Subject: Arkansas Nuclear One - Units 1 and 2
Docket Nos. 50-313 and 50-368
License Nos. DPR-51 and NPF-6
Request for Additional Information Regarding the July 10, 2003, Fire
Protection Regulatory Conference

Responses to NRC Questions from July 10, 2003, Regulatory Conference

Figure 1: CFAST results for scenario 1a with open doors and mechanical ventilation

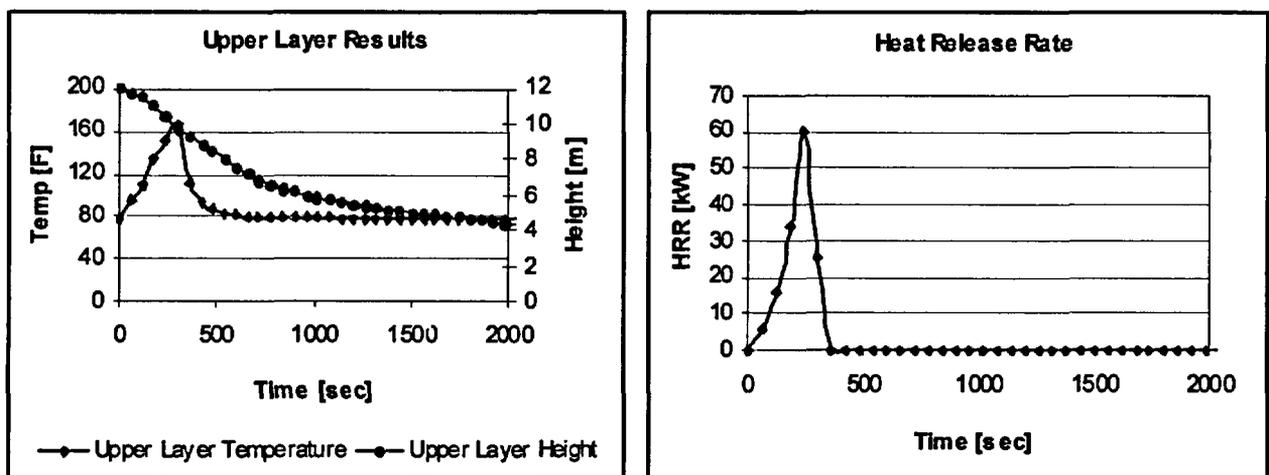
Please provide the CFAST model results for Fire Zone 99M, assuming forced ventilation is not secured and continues to supply air to the fire throughout the duration. In addition, please provide the input files you used in the CFAST fire simulation in all fire scenarios for Fire Zone 99M.

Figure 1 describes the results for Scenario 1a which consists of an elevated growing fire. The results indicate that if the door to zone 99-M is assumed open, the smoke layer will reach four feet high and temperatures in the room will reach a peak of 160° F. However, because the fire is immersed in smoke, the available oxygen in the room is consumed and the combustion process cannot be sustained. The temperature of the room is expected to return to ambient in around ten minutes. In this case, the ventilation system does not supply enough oxygen for supporting the fire. Furthermore, the injected air increases the size of the smoke layer, which completely covers the fire. This injected air also reduces the temperature of the hot gas layer.
